RE: VARIANCE REQUEST – Addington/Burrows Property

1718 Pleasant Plains Road Annapolis MD- Storck Property Lot 2, P.B. 185, PG.36-37
TA# 3000-9009-4120, Tax Map 46, Grid 4, P/O Parcel 236
Permit Nos. G02019523/B02433351

SITE DEVELOPMENT AND GRADING PLAN FOR LOT 2 OR 2.690 ACRES 1718 PLEASANT PLAINS ROAD

CONFIRMATION OF PRE-FILE (2025-0099-P)

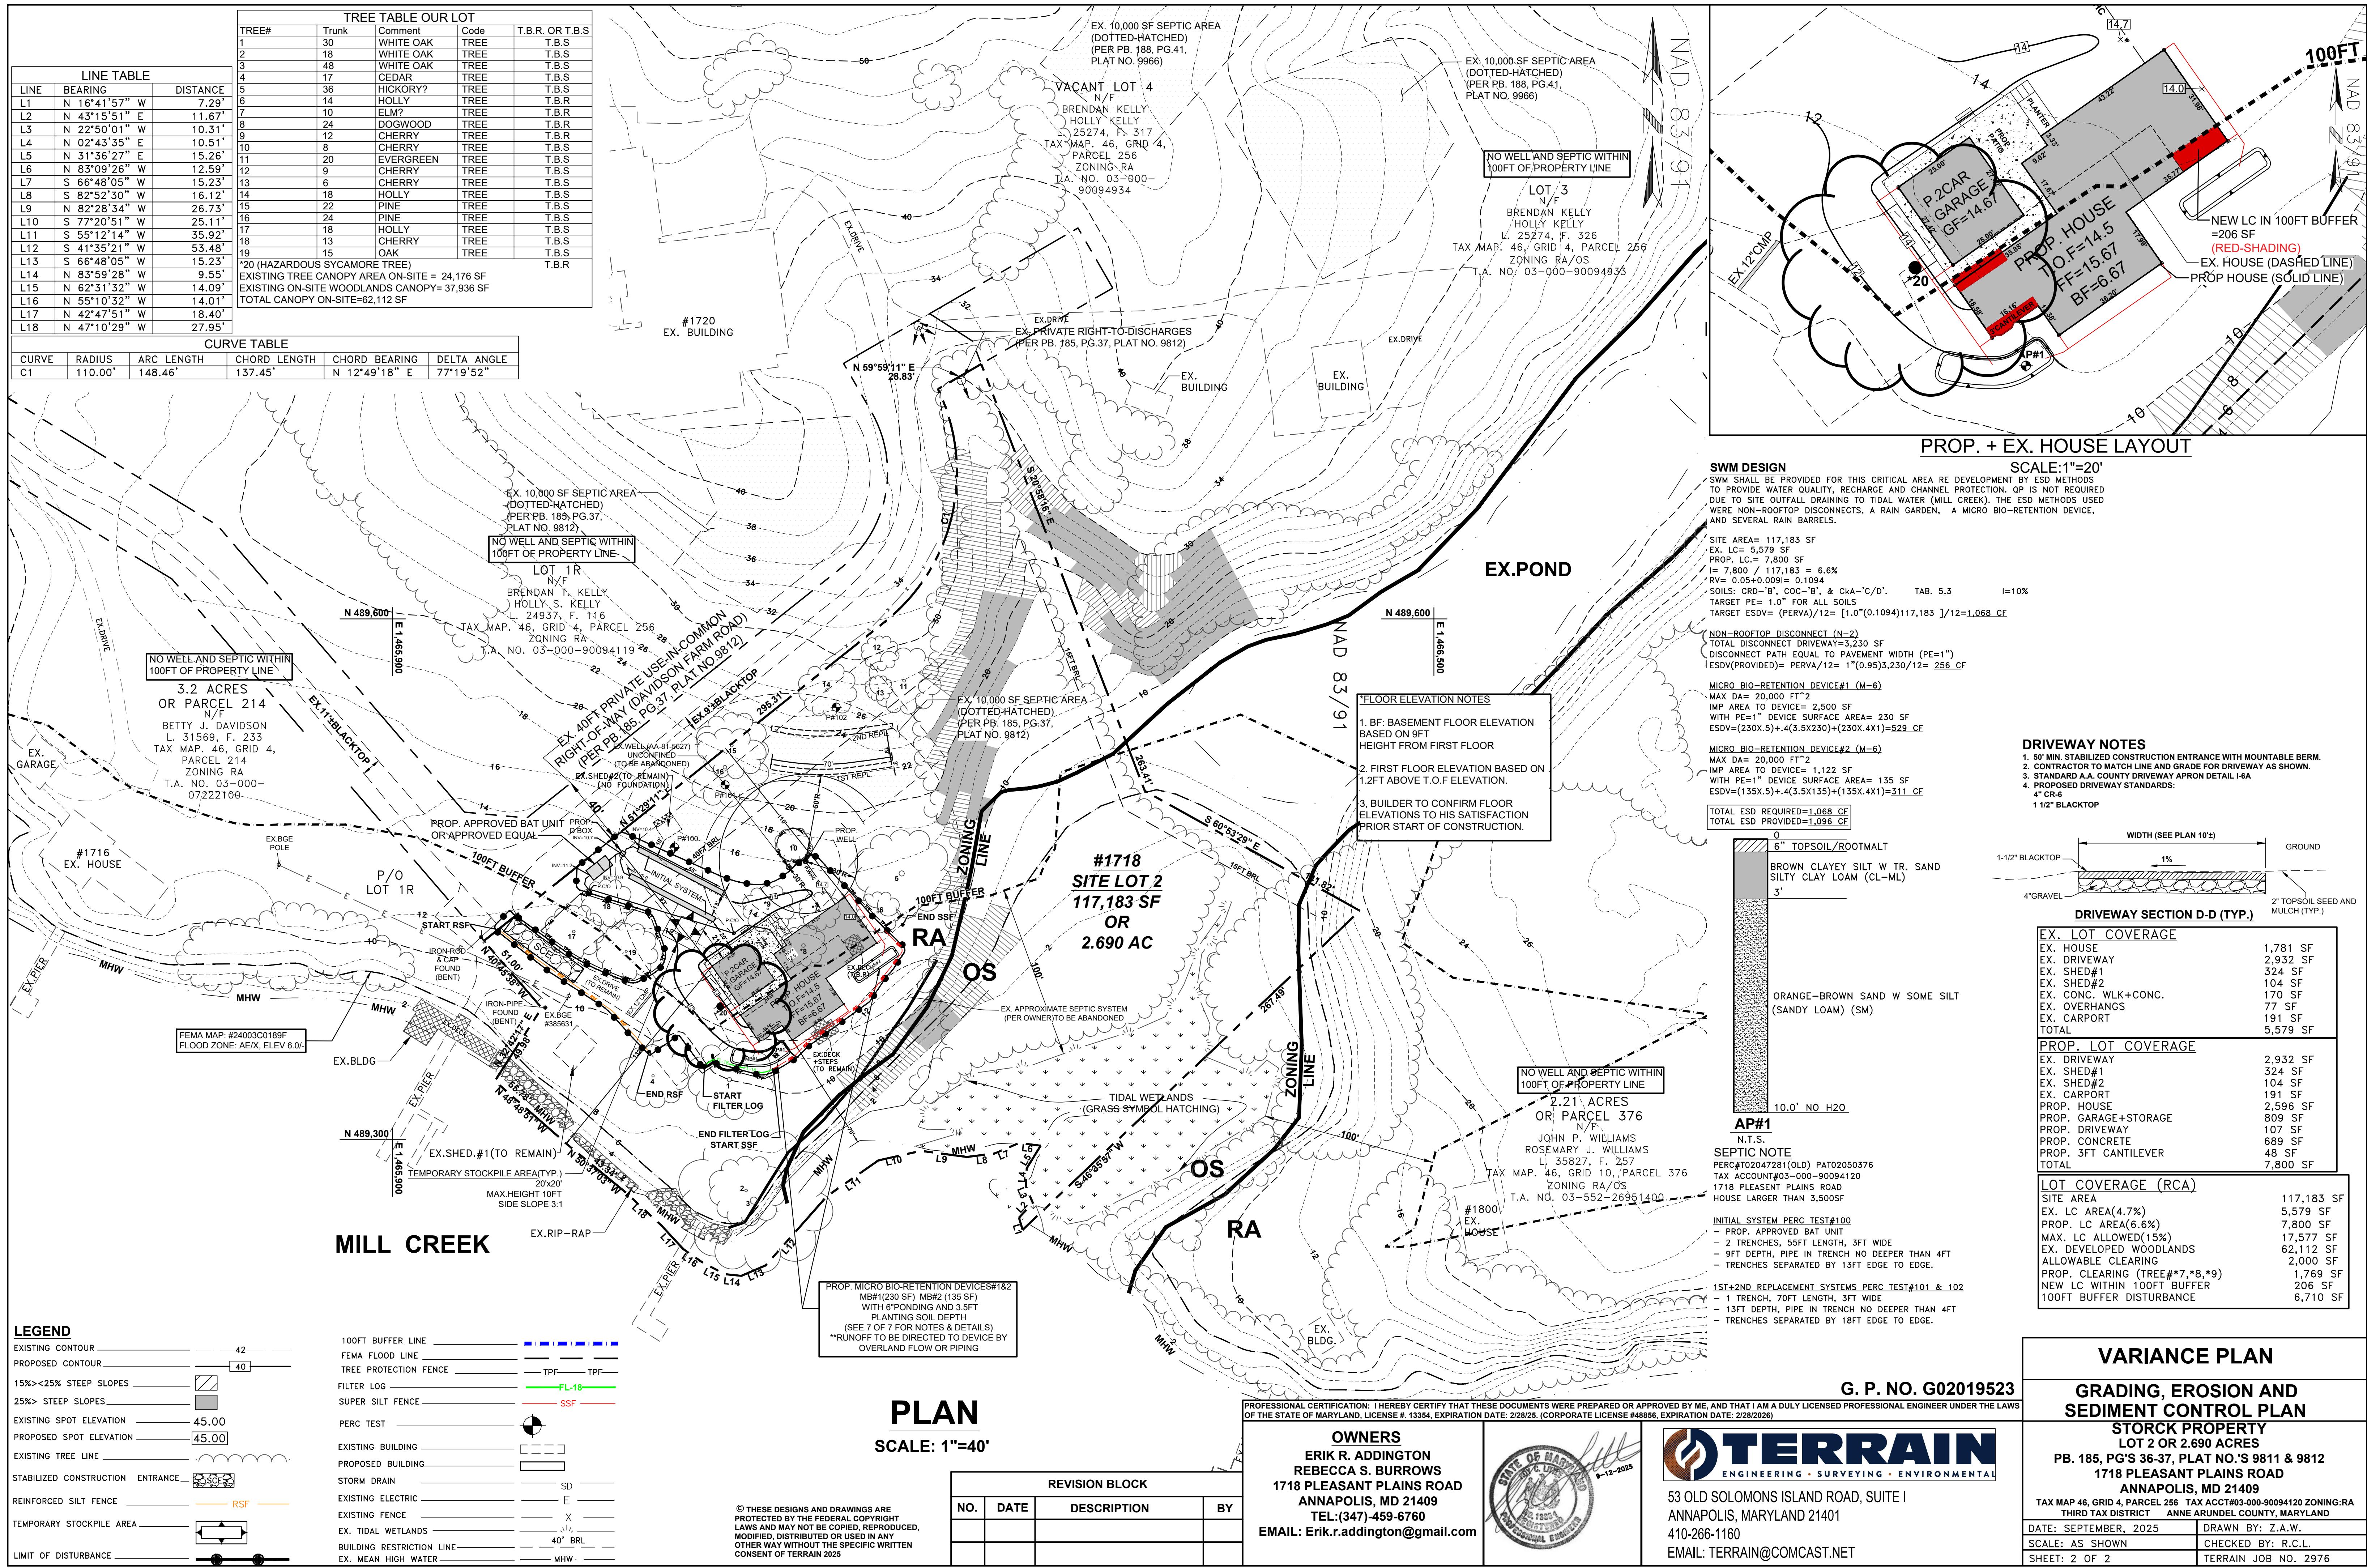
- 1) Based on the plan provided, it appears that the property will be served by private septic system and water well.

2) Stormwater management will be addressed through two micro bio facilities and will be reviewed during grading permit approval. The grading permit # G02019523 is not approved/issued yet.

3) The soil boring required with the grading permit plans to verify the depth of seasonal water, suitability and siting of the proposed SWM practices. Determination/Recommendation – based on the above, this office has no objection to provide relief to tree clearing/removal and the time extension of approved variance: however, the decision is deferred to the office of Planning and Zoning

The **Critical Area Team** commented that, unfortunately, this issue is not eligible for a variance. I [Kelly Krinetz] did discuss this with Mr. Little and advised him that a variance would be required, but that was based on the question posed to me which was to allow clearing over 30%. The clearing limit for this property is based on a plat note which cannot be altered through the variance process. While this application states that the tree was removed because it was a Hazardous Tree, the property owner did not follow the guidance document that was included for Hazardous Trees. The document states that an arborist report is required. One was not obtained, and the photos that are available and were submitted, do not clearly support that claim. In addition, the tree in question was included on the first application and was slated to remain on the grading permit. This office issued comments regarding the clearing limitations and the tree was subsequently removed. I would advise the applicant to contact the Critical Area Team to set up a meeting to discuss a resolution to this issue.

The **Zoning Administration Section** defers to the Critical Area Team with regard to the tree removal and their determination that a clearing variance is not a potential path forward. With regard to the request for a time extension variance, the Zoning Administration Section would have no objection to additional time as long as the applicants can adequately demonstrate with their variance application that they have been actively and diligently working towards obtaining their permit approval.
